Regis Belrose Residential Aged Care Facility – 181 Forest Way, Belrose

Civil Stormwater Section 4.56 Amendment Letter

FIGURE 2 – PROPOSED MODIFICATION TO OSD AND WSUD STORMWATER MANAGEMENT LAYOUT

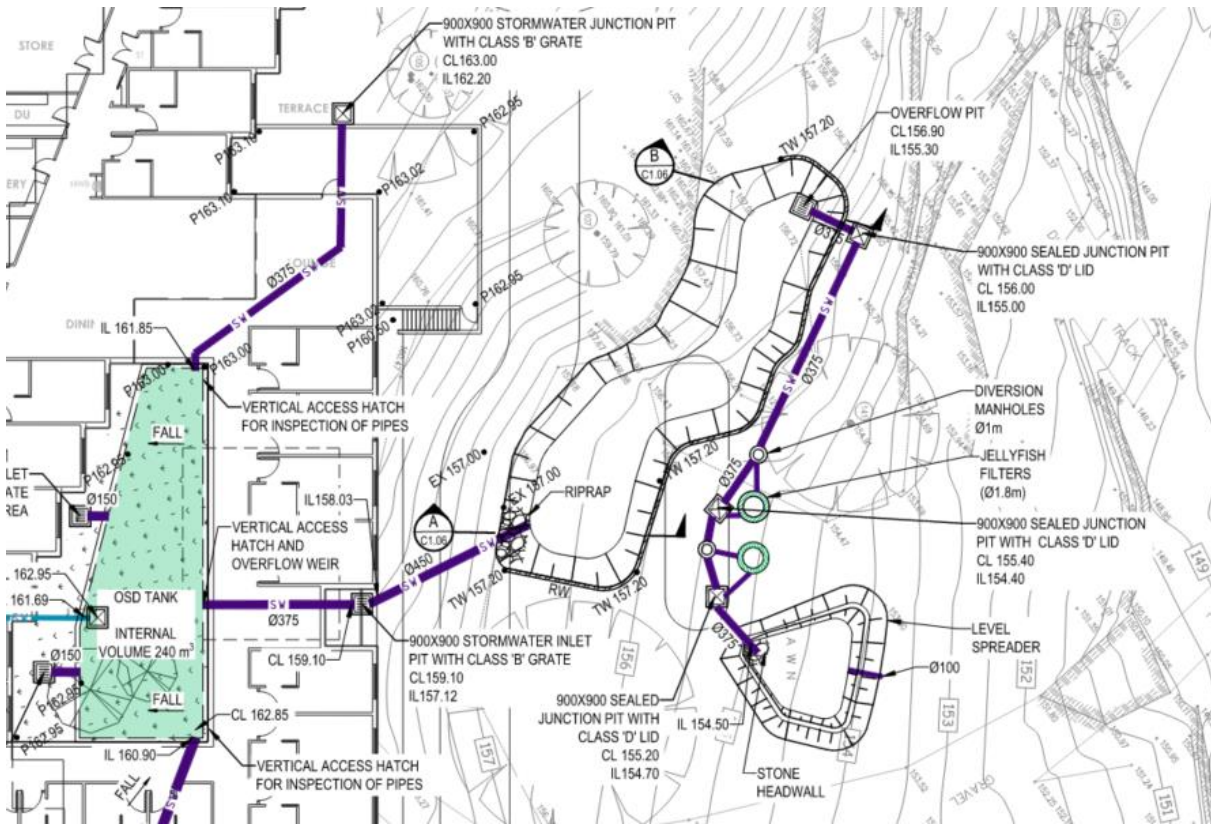
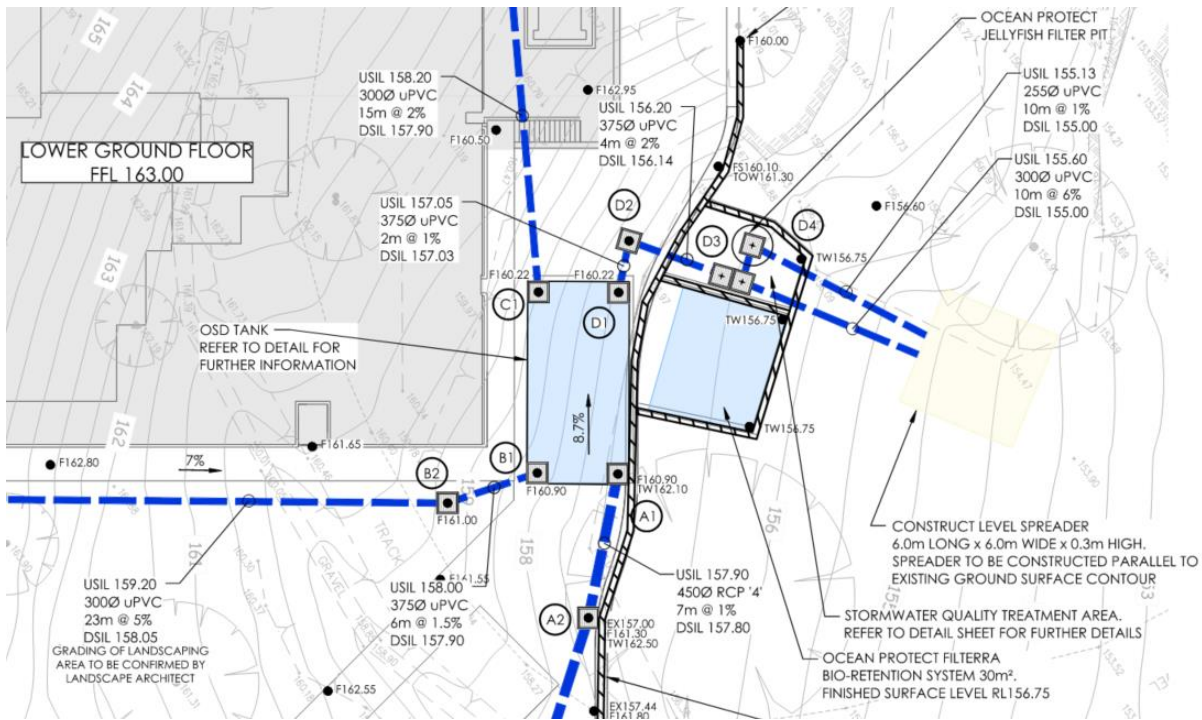
These modifications along with the previous stormwater design changes as noted in the ACOR Consultants S4.56 letter of intent have been incorporated into the current Civil stormwater management plans as part of this S4.56 modification. The changes include;

- Relocation of the OSD from the building's internal courtyard to outside the building footprint
- Amendments and substitution of the WSUD stormwater quality treatment devices

These amendments are represented in Figures 1 and 2 below which show the approved stormwater strategy and proposed modification. The proposed design does not alter the intent of the approved site stormwater management strategy and still meets the Council requirements as stated in the approved development consent conditions and Council DCP for both onsite detention and water quality measures. This is discussed in more detail below.

- Primary Treatment
 - 18x Filter basket pit inserts Ocean Guard supplied by OceanProtect
- Secondary Treatment
 - OSD tank with trash screen to remove fine sediments and gross pollutants
 - 30m² Filterra bio-retention basin supplied by OceanProtect
- Tertiary Treatment
 - 1x Jellyfish filtration system supplied by OceanProtect

Both the approved and proposed designs utilise proprietary treatment products supplied by OceanProtect to achieve the required pollutant reduction targets. The design has been modified in consultation with OceanProtect and removes the bio-retention basin and 1x of the Jellyfish filters and replaces them with the OceanProtect Filterra bioretention system.

This system provides a better outcome as it removes the use of the dual in-series Jellyfish system which OceanProtect has advised is not a preferred arrangement for pollutant removal or hydraulic performance. The proposed treatment train, utilising the Filterra bio-basin, provides a more natural WSUD outcome that will fit into the surrounding landscape and reduce the future maintenance requirements on the facility.

FIGURE 3 – OSD DETAIL

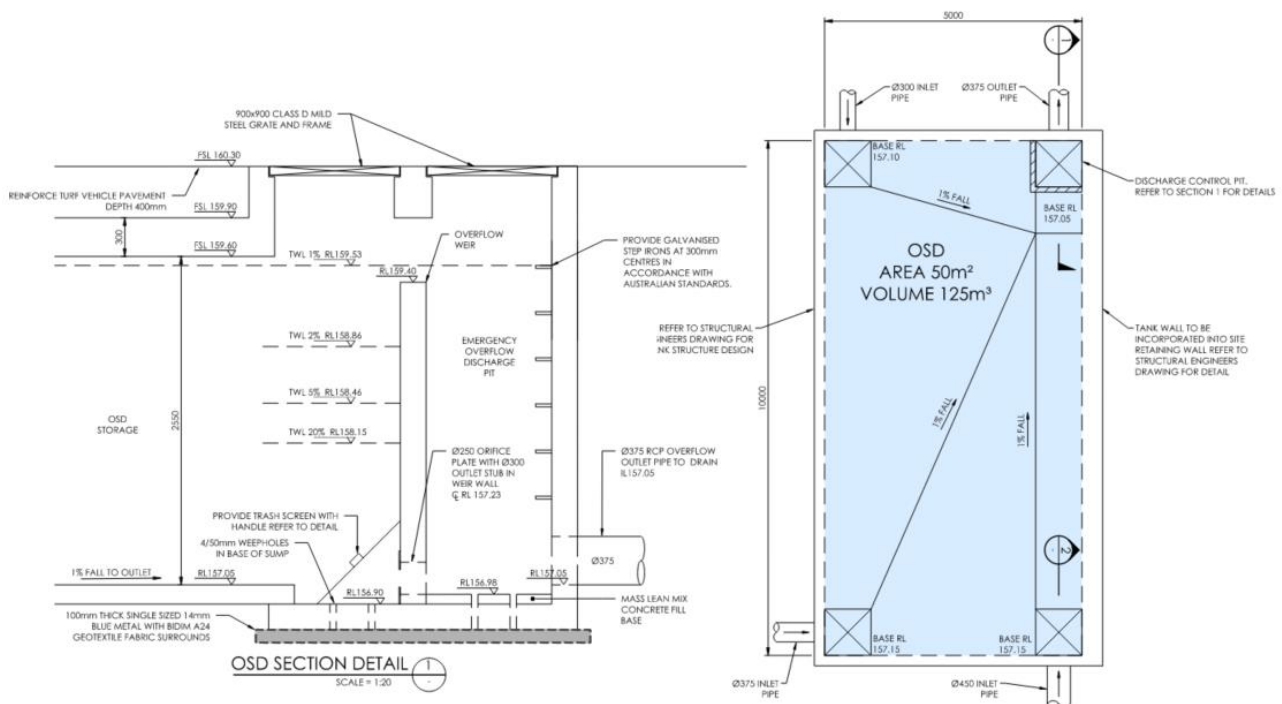
The OSD tank is proposed to be relocated from within the building's internal courtyard to outside the building footprint. It is to be located beneath the rear access road for fire truck egress to the eastern portion of the site for bushfire fighting purposes.

The access road is required to be filled 3m and as such a large retaining structure is located along the perimeter of the road. The OSD tank is proposed to be incorporated into the wall structure and utilises the void space beneath the roadway, allowing for a depth of 2.55m above the existing surface and subsequent outlet pipe.

This location is an improvement on the previously approved design as it allows an emergency surcharge point at the tank lid point which is external to the building and below the finished floor level. The OSD design can also utilise the existing steep topography to its advantage, allowing for a deeper tank with a free draining outlet without tailwater restrictions which improves the hydraulic performance of the drainage system.
